Installation of New ALPS treated Water Dilution/ Discharge Facilities and the Related Facility

February 1, 2022

Tokyo Electric Power Company Holdings, Inc.

Responses to major issues*¹ concerning the content of the application for the Discharge Facilities of ALPS Treated Water into the Sea

Logic circuit for an emergency isolation valve

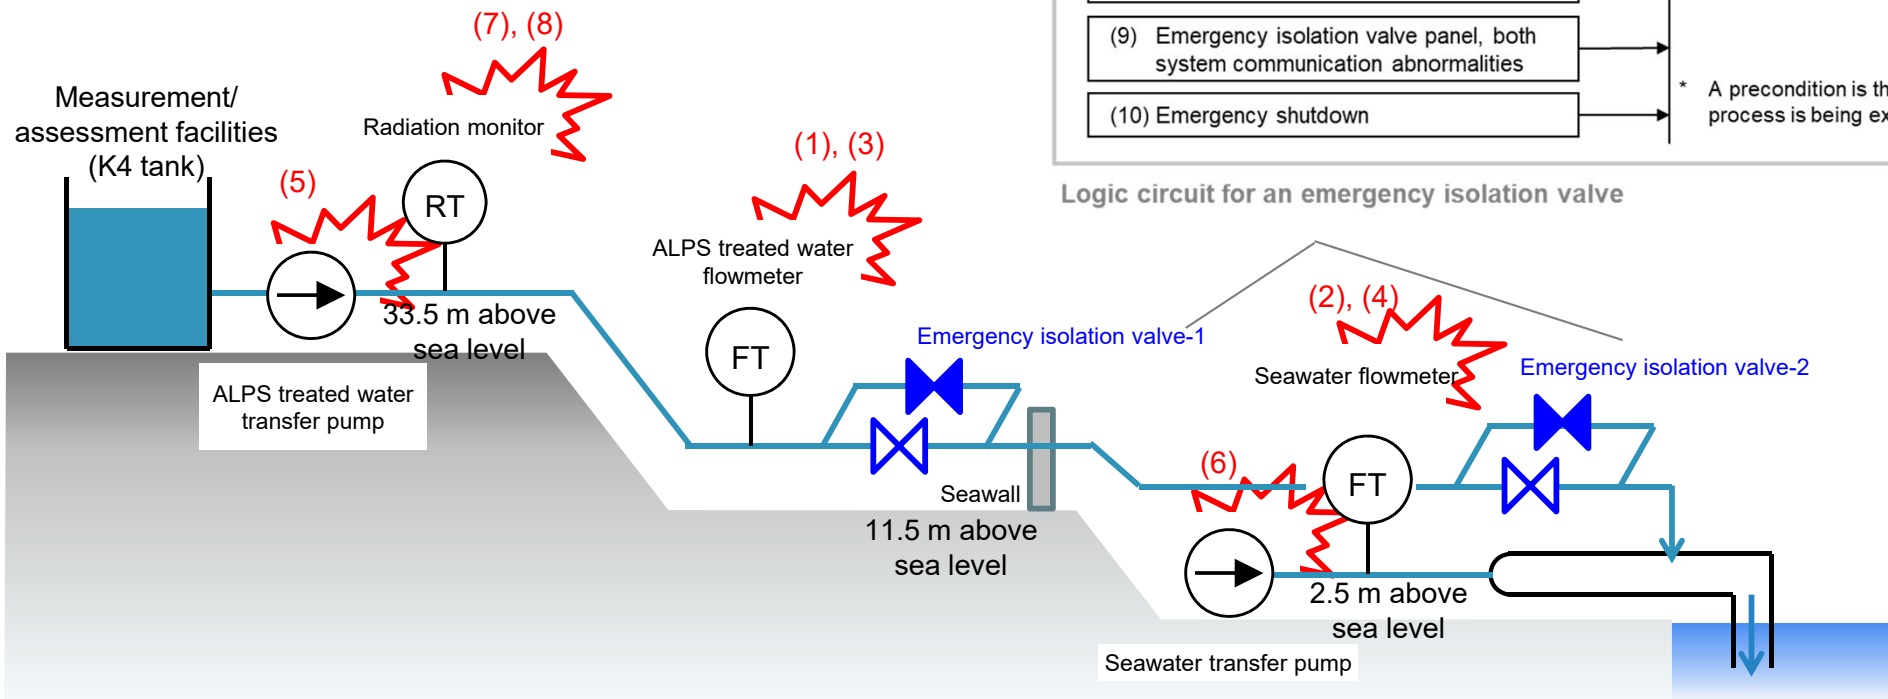
- As for the interlock mechanism, the role expected, the logic circuit, and the concept of various set points shall be explained in an organized manner.

- The operating conditions under which the emergency isolation valve is “closed ” are as shown in the figure below, which is designed to prevent “unintentional discharge of ALPS treated water into the sea.”
- The logic is that when various kinds of abnormalities are detected, the sound seawater transfer system will continue the operation and dilution as much as possible.

[Note] Assessing the discharge amount at the time of a single failure of emergency isolation valve-2

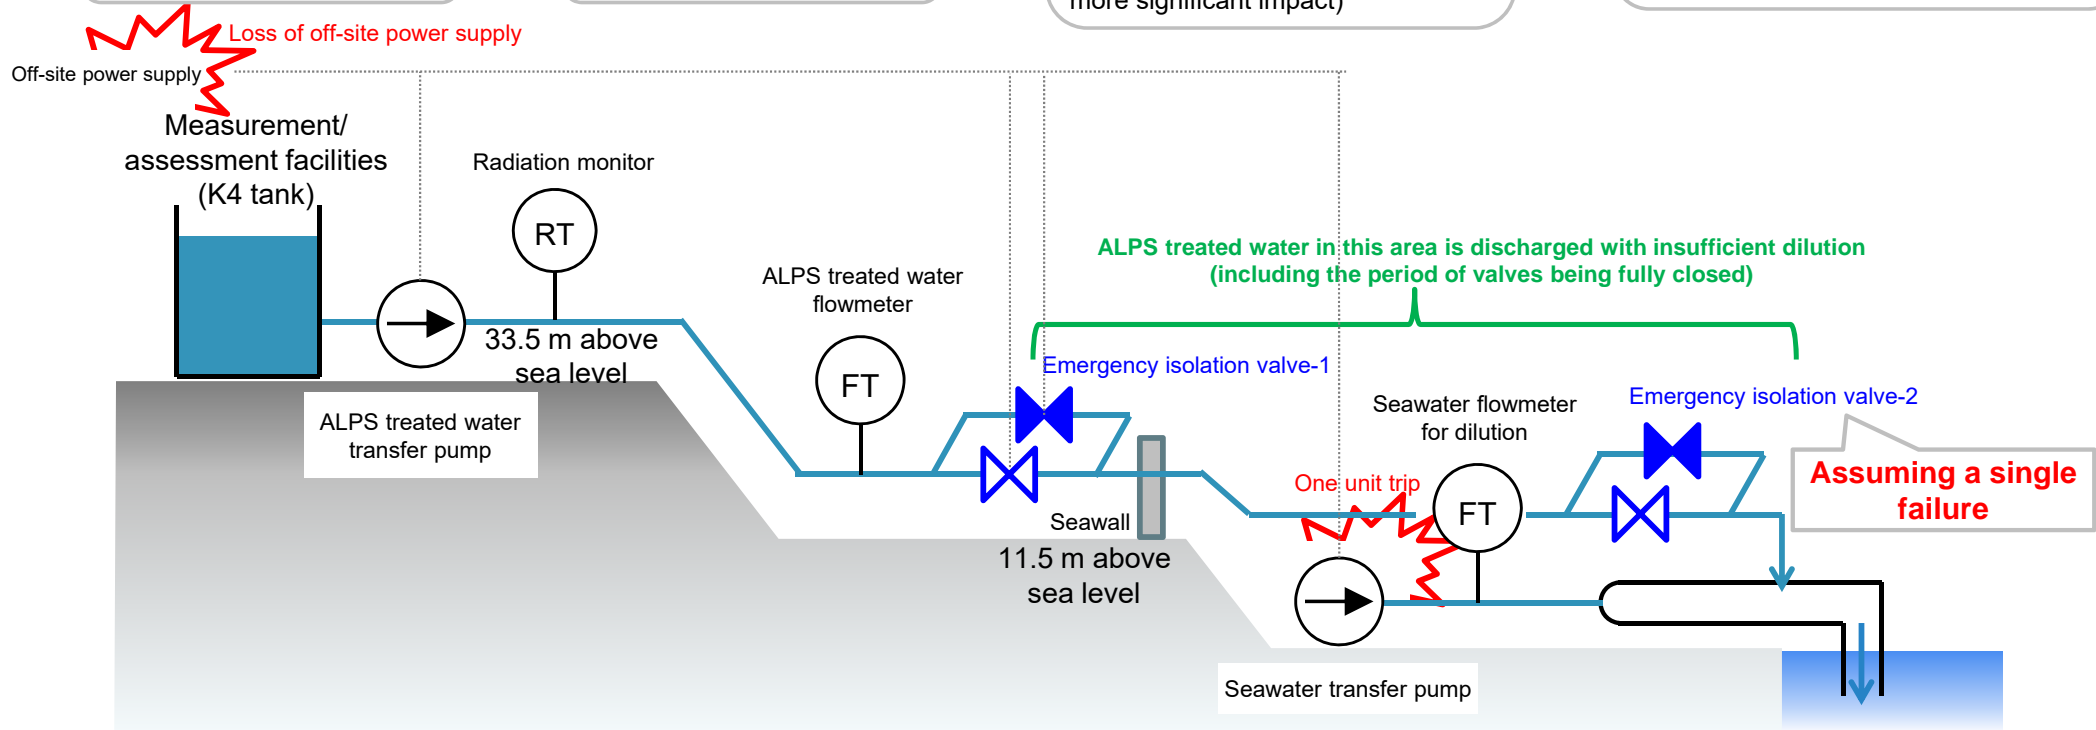
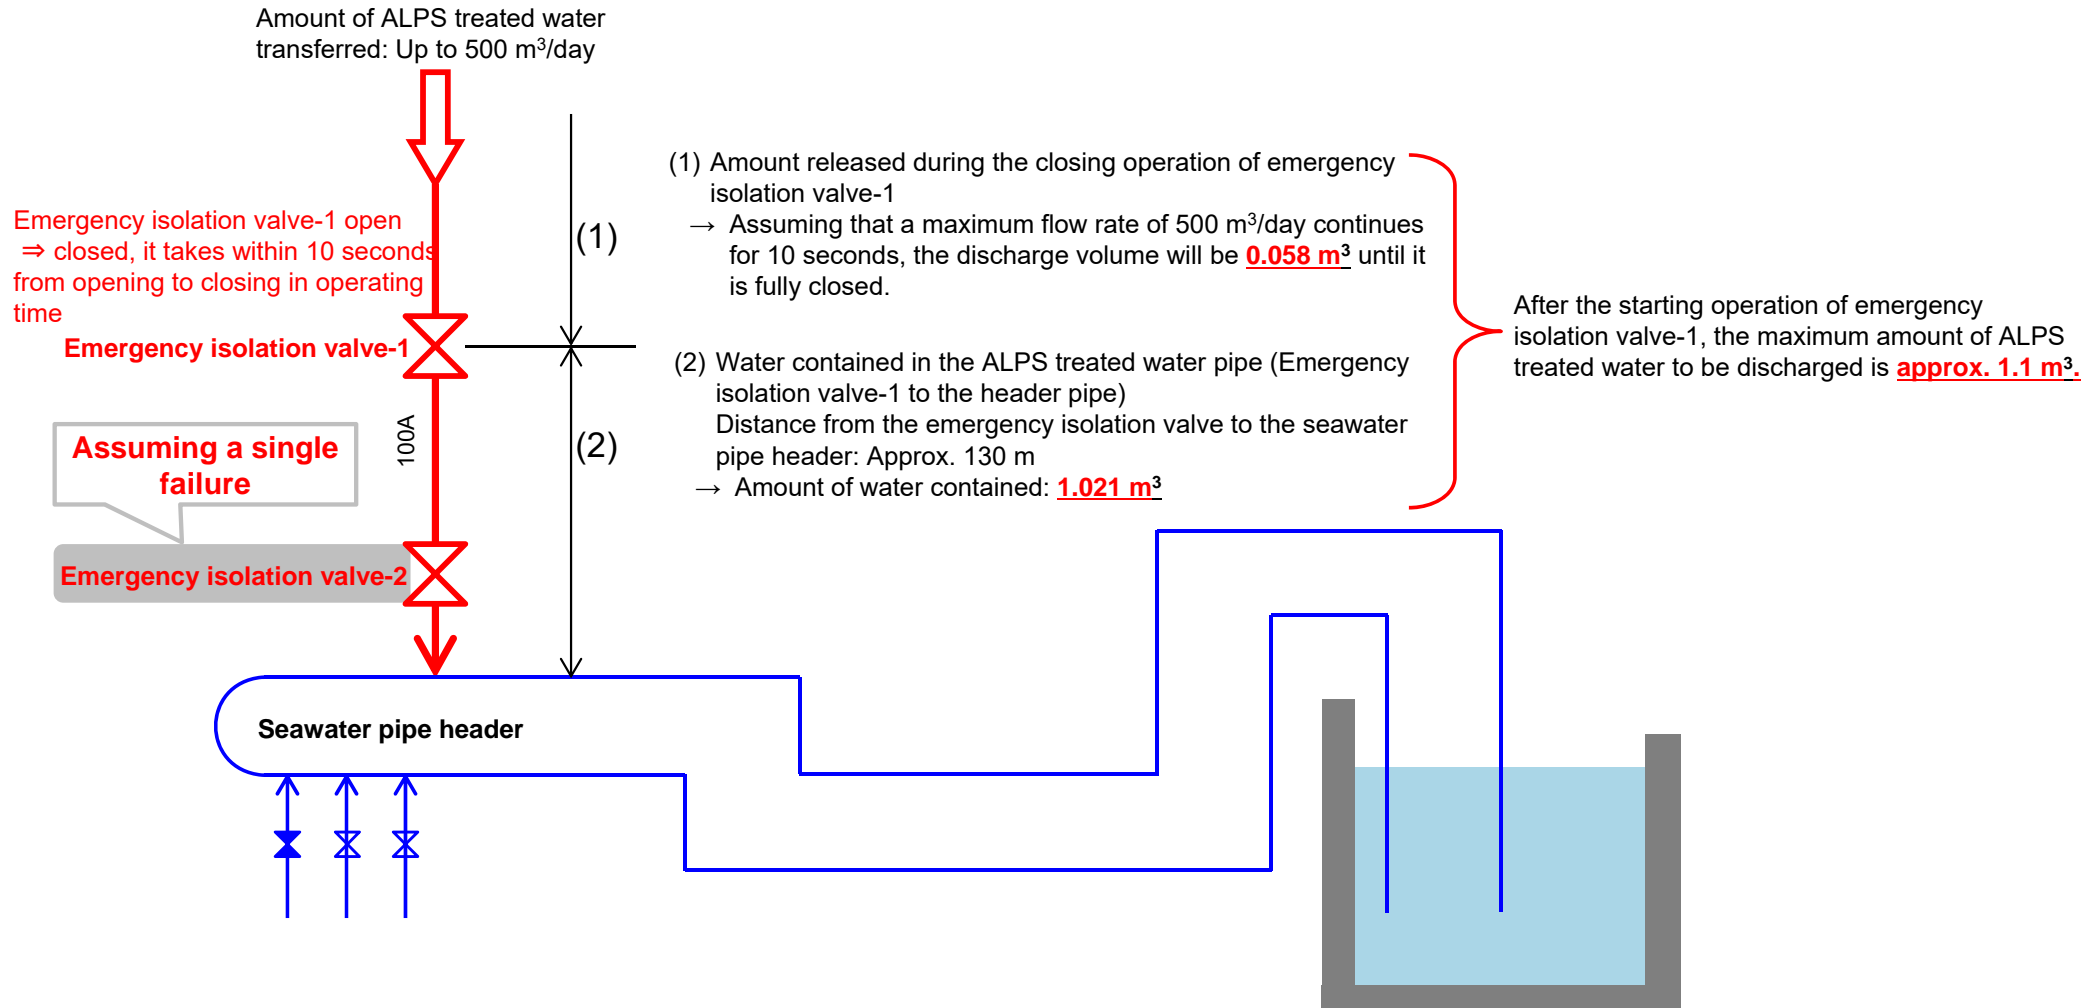
- Explanations shall be given regarding facilities, systems, and procedures necessary to cope with the postulated unintentional discharge of ALPS treated water into the sea due to trouble during discharge, such as equipment failures (hereinafter referred to as “abnormal event”), and discharge amount after those measures are taken shall be evaluated.
- When performing the above-mentioned evaluation, the most severe abnormal event shall be selected in terms of the amount of ALPS treated water discharged and, when analyzing, a single equipment failure that will lead to the most severe consequence shall be assumed.

An emergency isolation valve is usually operated; however, in this case, a single failure of the applicable equipment is assumed. (assuming a failure of the emergency isolation valve-2 with a more significant impact)

Until emergency isolation valve-1 is fully closed, the ALPS treated water is discharged with insufficient dilution.
Discharge amount: Approx. 1.1 m³

- It has been confirmed that this discharge amount (approx. 1.1 m³) is sufficiently small compared with the currently planned discharge amount of ALPS treated water (up to 500 m³/day).
- Based on this, it has been confirmed that the design and operation of the ALPS Treated Water Dilution/Discharge Facilities are sufficient for ensuring safety.

Figure: Sea area monitoring point

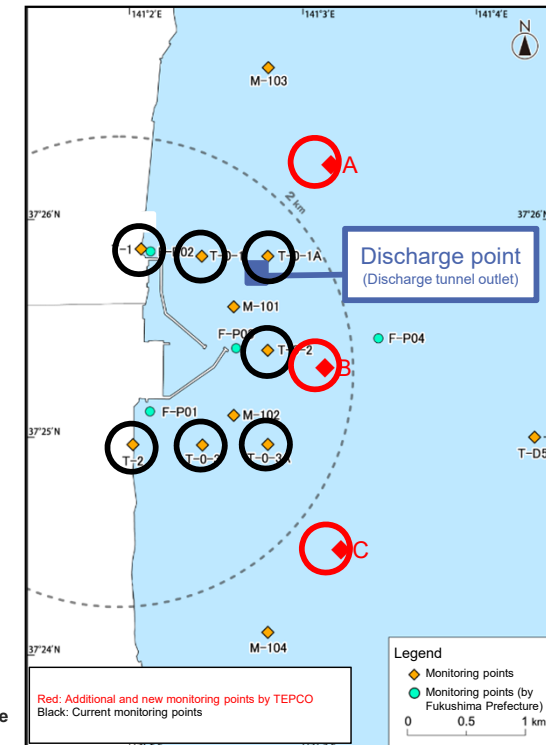
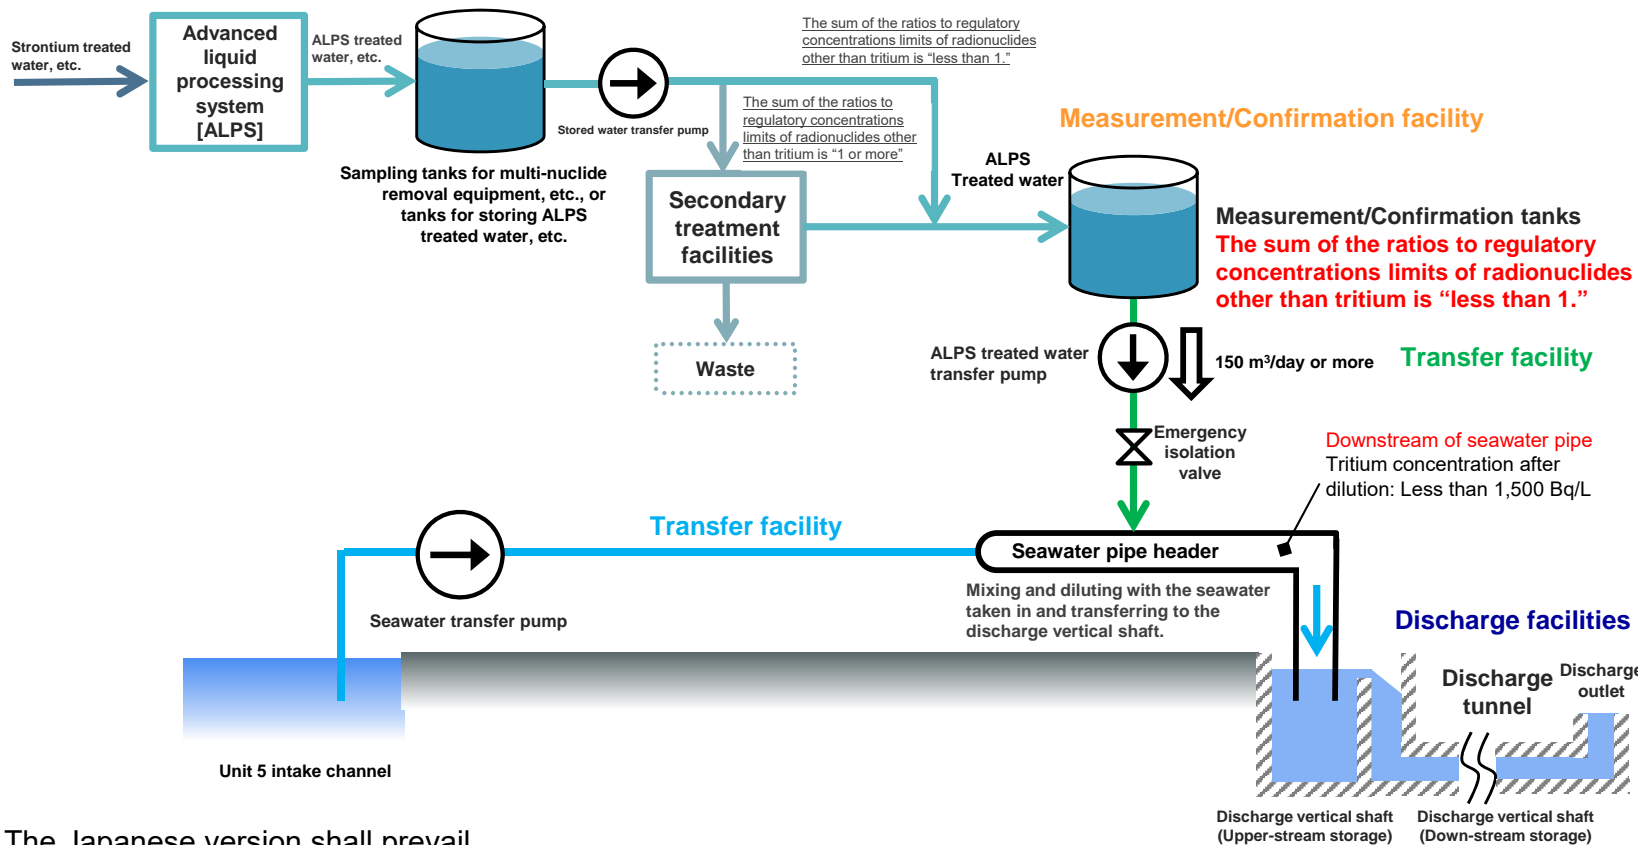
- Explanations shall be provided for judgment criteria and response procedures when abnormal values are detected in the sea area monitoring, and the discharge will be stopped.

- Response procedures in the event of detecting any abnormal values
 - (1) If any abnormal value is detected, immediately stop the discharge.
 - (2) Check the analysis results at downstream of the seawater pipe performed daily during discharge period and the flowmeter records. Then determine if any abnormalities occurs in discharge.

- (3) In the event that any abnormality is detected in discharge, investigate the operation and management aspects, such as facility abnormality including the discharge vertical shaft and seawater pipe, as well as dilution operation log, and resume discharge after taking necessary measures.

- (4) If the abnormality was caused by something other than discharge, investigate the factor of the increase of the value of tritium concentration, identify the cause, and resume the discharge by ensuring that the discharge is possible.

- (5) After the resumption of discharge, perform seawater sampling at 10 points for 3 days to check any abnormalities in the sea area monitoring.
